OPTIONAL SERVICE BULLETIN NO. DAC1-33-08 REV. 0

Type: DA 20-C1

This service bulletin addresses the replacement of the current installed landing and taxi lights with the new LED landing light and taxi light assemblies onto the DA 20-C1 aircraft using Whelen's 71125 series LED recognition lights.

Figure 1. 4th holes.

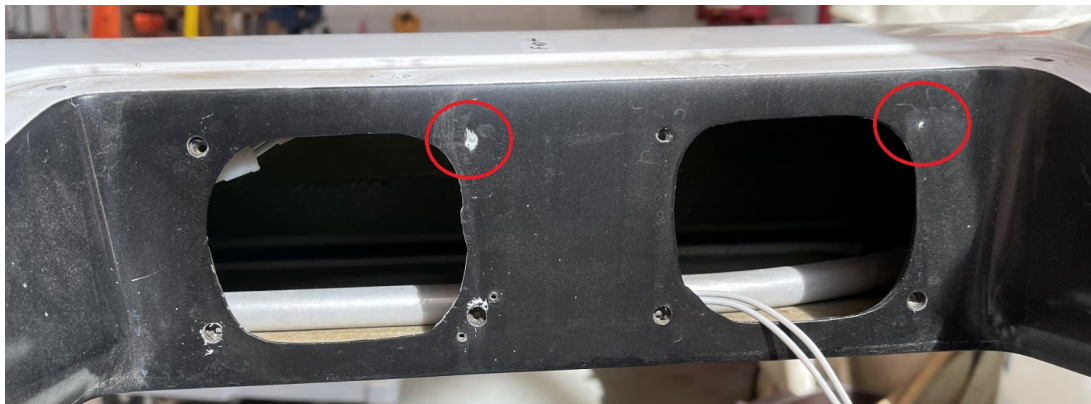
A. Locate the 4th holes. Refer to Figures 1 and 2.

Figure 2. Hole dimensions.

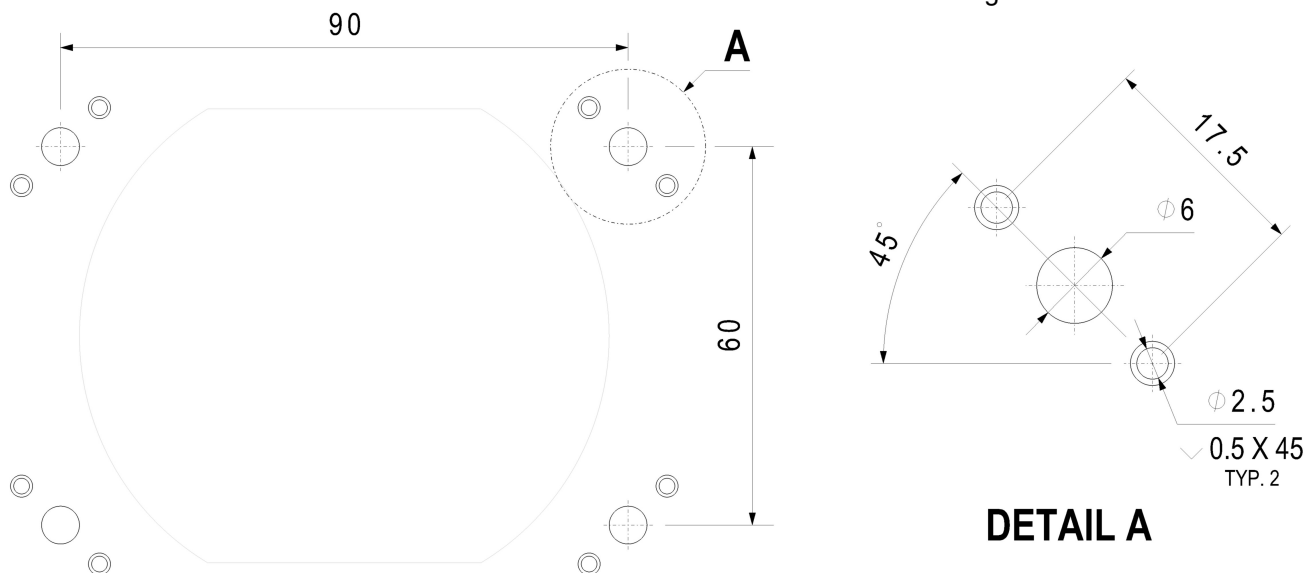
B. Drill and countersink holes for the anchor nuts and rivets. Refer to Figure 2 for dimensions.

NOTE: Make sure the area is clear of any wires before drilling.

Figure 3. New LED lights location.

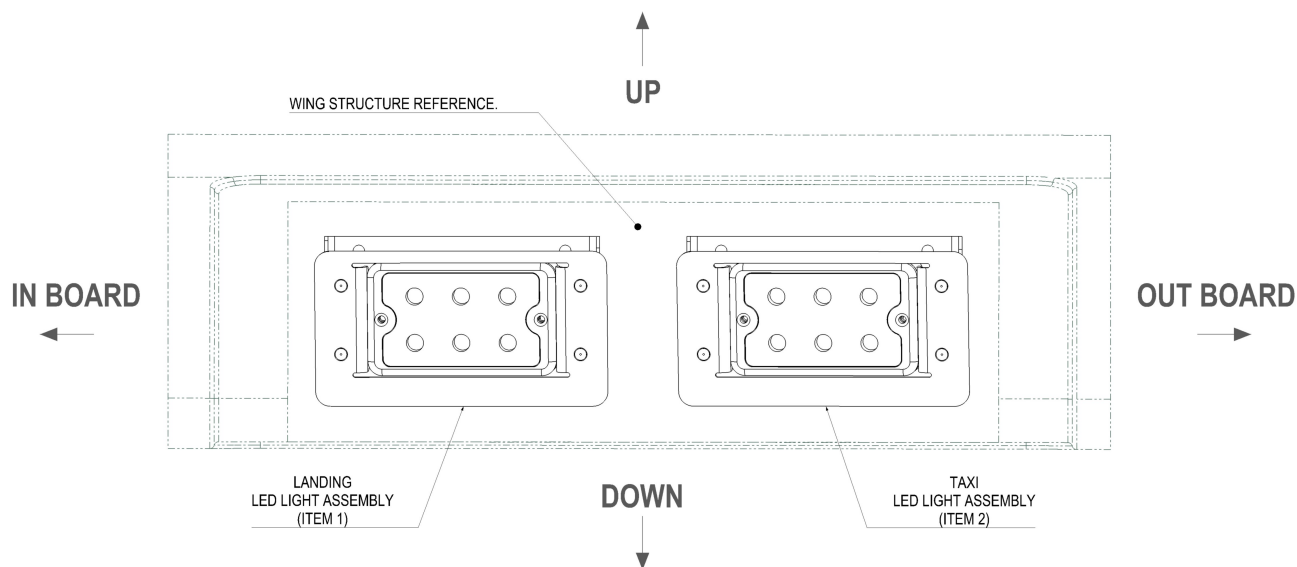
A. Hold the landing light assy (Item 1) in position at the leading edge of the left wing and connect the electrical connector P3340-10 to the wing electrical connector J3340-10. Refer to Figures 3 for location, and 4 for identification markings.

- B. Install the landing light assy (Item 1) using screws (Item 3) and washers (Item 4).
5. Install the taxi light assy (Item 2) as follows:
- A. Hold the taxi light assy (Item 2) in position at the leading edge of the left wing and connect the electrical connector P3340-11 to the wing electrical connector J3340-11. Refer to Figure 3 for location, and 4 for identification markings.
- B. Install the taxi light assy (Item 2) using screws (Item 3) and washers (Item 4).
